## ON-SITE SEWAGE DISPOSAL SYSTEM HOWARD COUNTY HEALTH DEPARTMENT BUREAU OF ENVIRONMENTAL HEALTH

SUBDIVISION: Chapel Woods II LOT NUMBER: 26

ADDRESS: 11833 Chapel Estates Drive PROPERTY OWNER: William Koenig

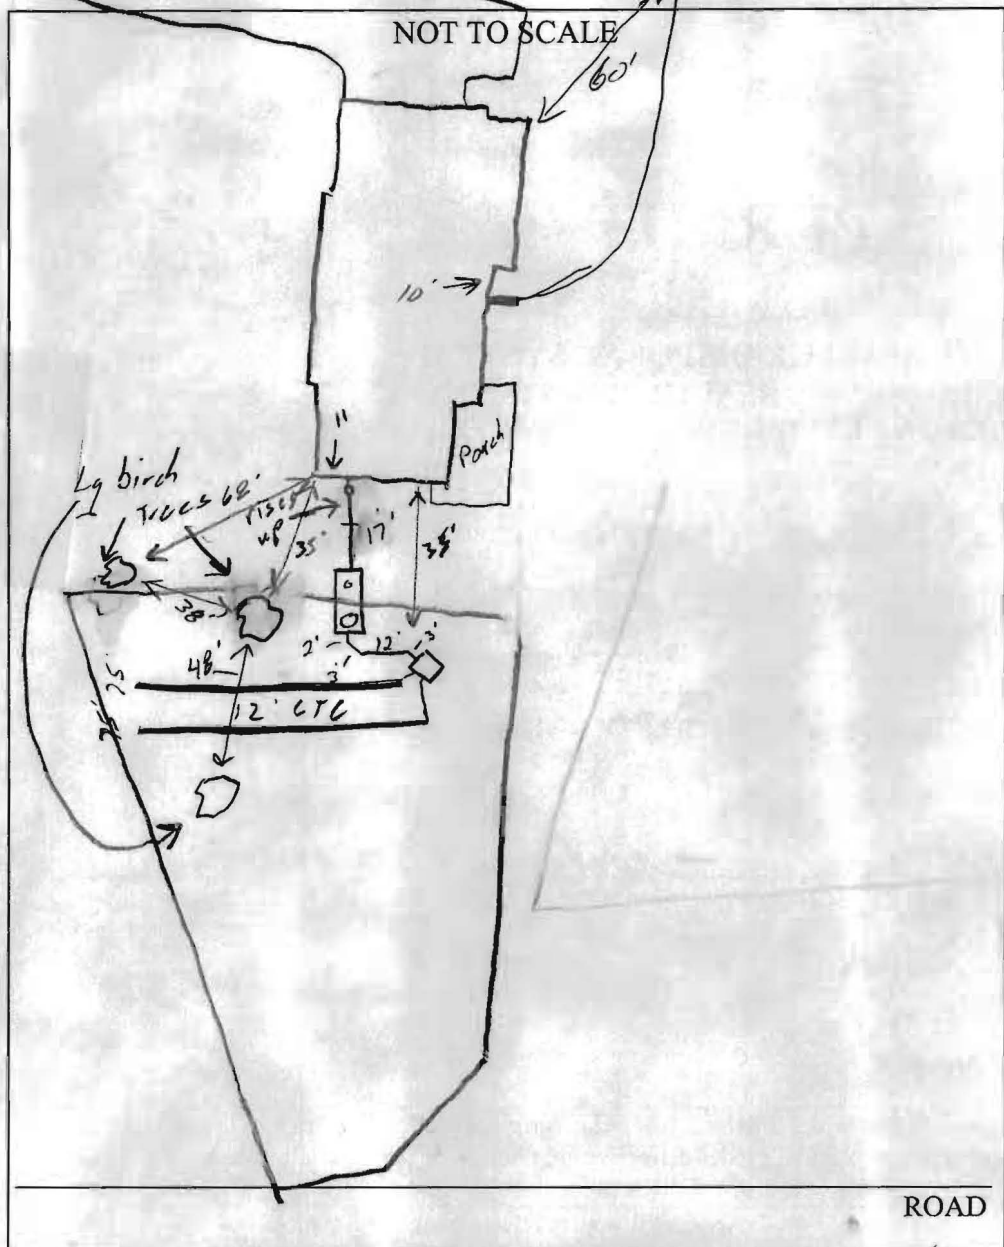
NEED TO ADDRESS LARGE TREE ISSUES DURING LAYOUT

PRE-CONSTRUCTION 5/13/04 No show (SO) 5/17/04 - SRA staked,  
contour accurate, install (3) 50' trenches - 9' CTC to make best  
 INSTALLATION use of area between (2) very lg. birch trees (SO)  
6/1/04 - Builder told contractor they must stay 15' off lg birch  
trees. (2) trees are in SRA. Contractor reconfigured trenches  
to (2) 75' trench to fit between lg trees (SO) 6/2/04 -  
System completed OK to cover - Need to check  
grading at house conn, pipe currently at grade (SO)  
10/5/04 House connection covered with fill. I assume it will  
be o.k. (BB)

DESIGNED	LOCATION DRAWING 11833 CHAPEL ESTATES DRIVE LOT 26	SCALE	1"=30'
DRAWN	CHAPEL WOODS II LOTS 26 & 27	DRAWING	
CHECKED	A RESUBDIVISION OF LOT 25 SHOWN ON PLAT NO. 9327 5TH ELECTION DISTRICT HOWARD COUNTY, MARYLAND	JOB NO.	
DATE	3-3-04	FILE NO.	02-008-0

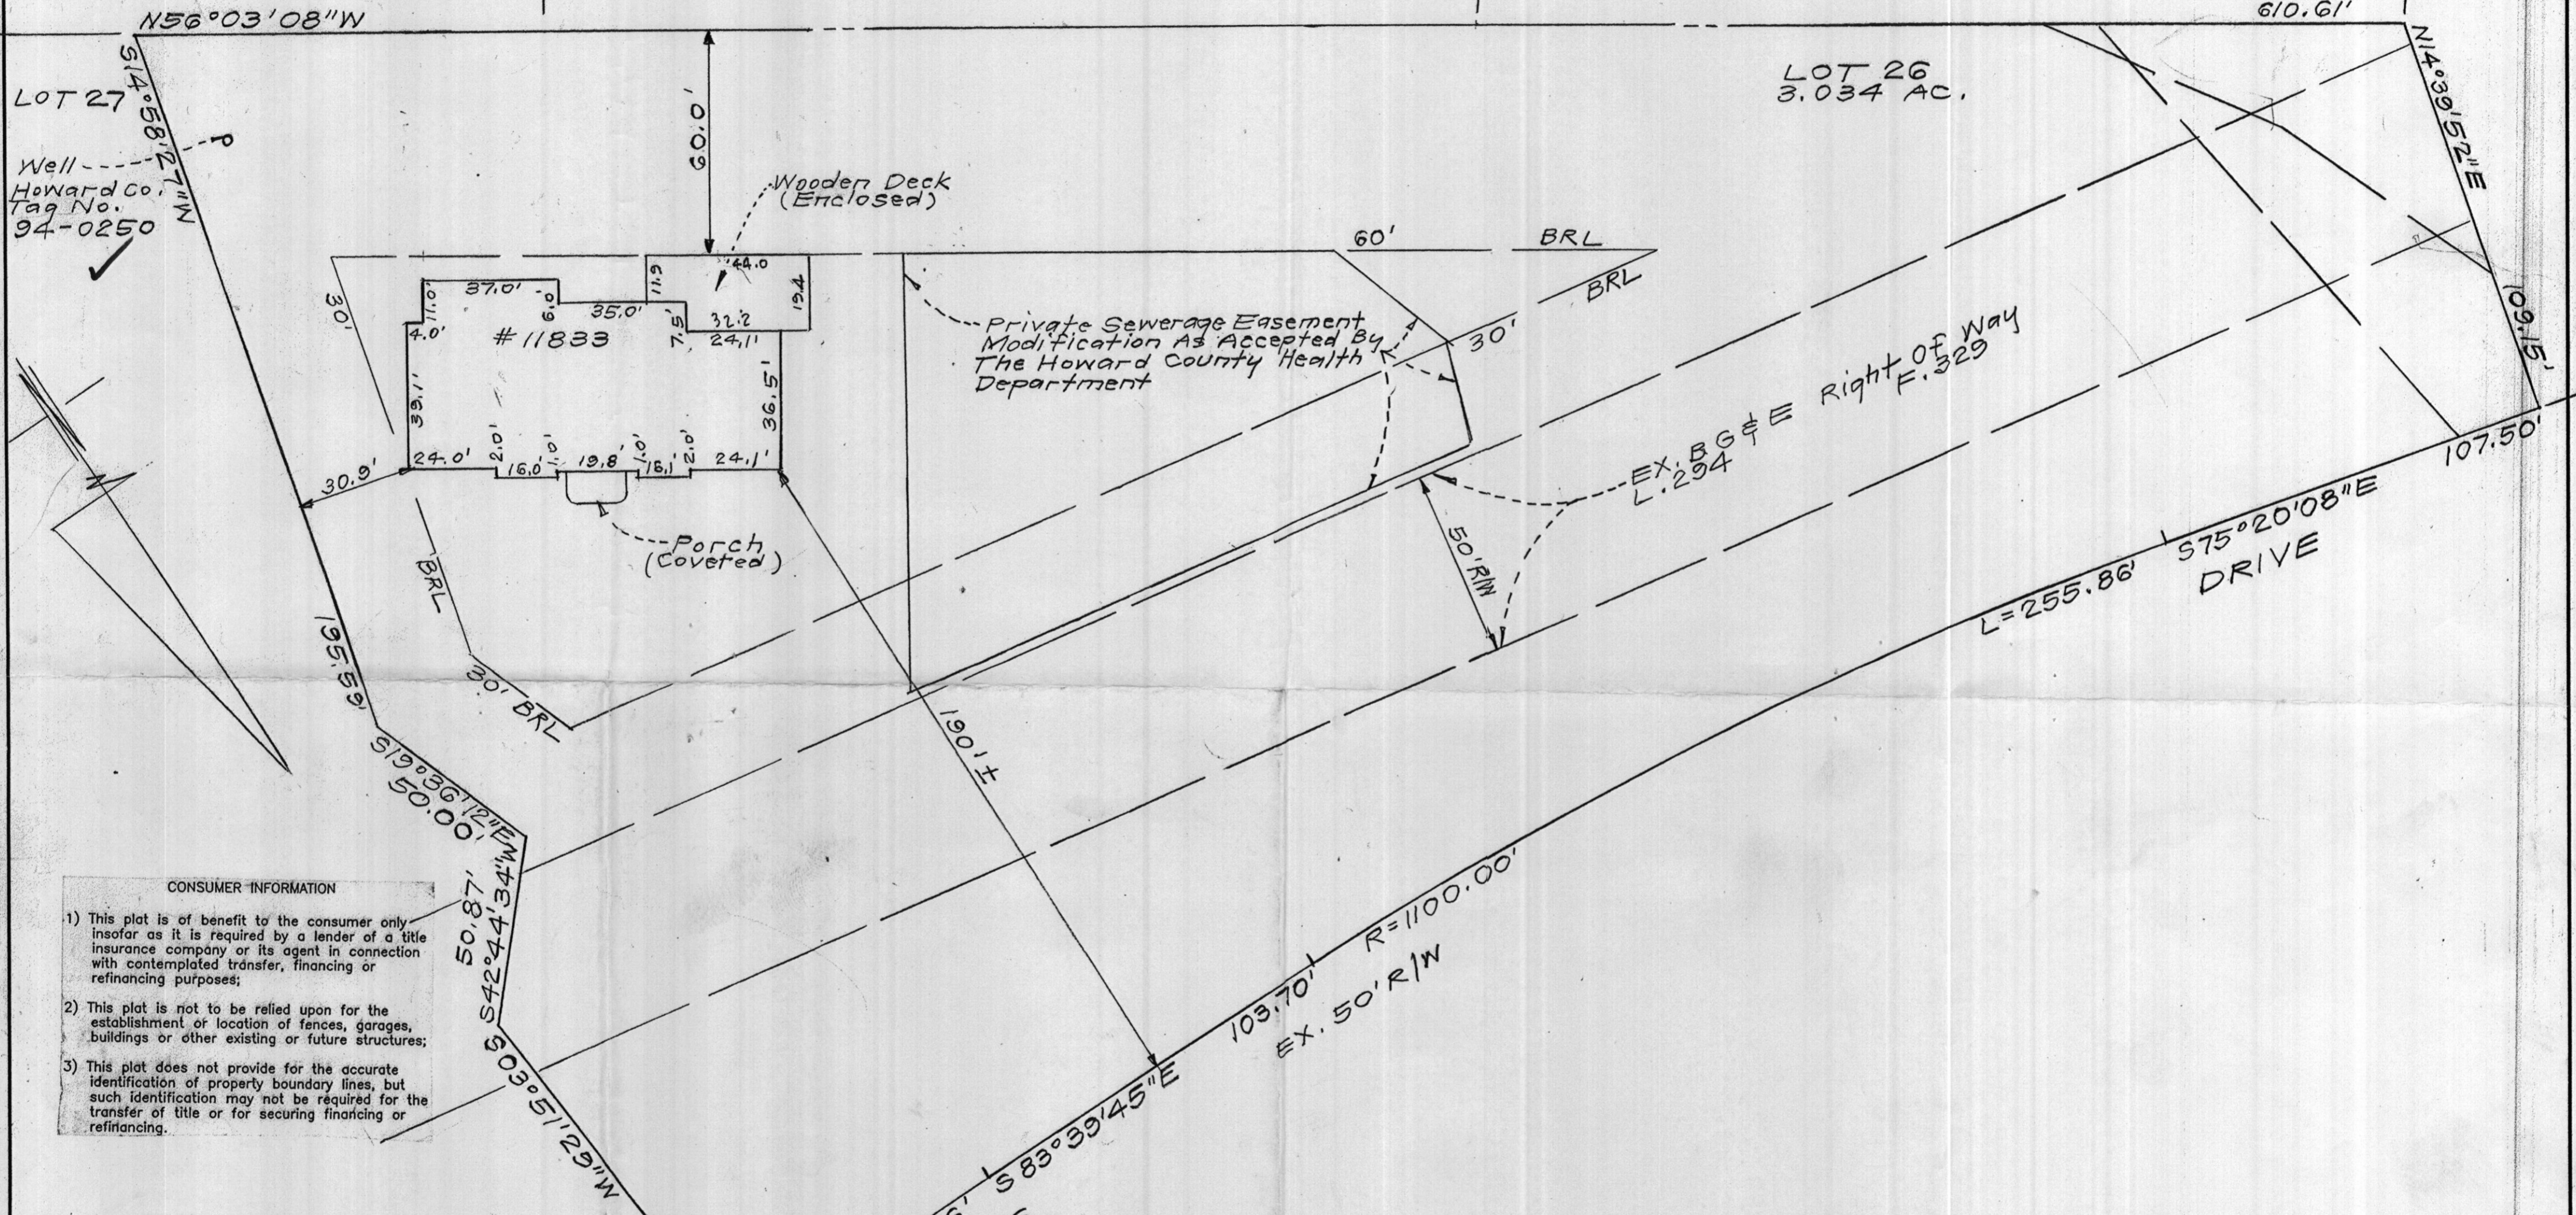
5/10/04  
Wall Check OK  
KN
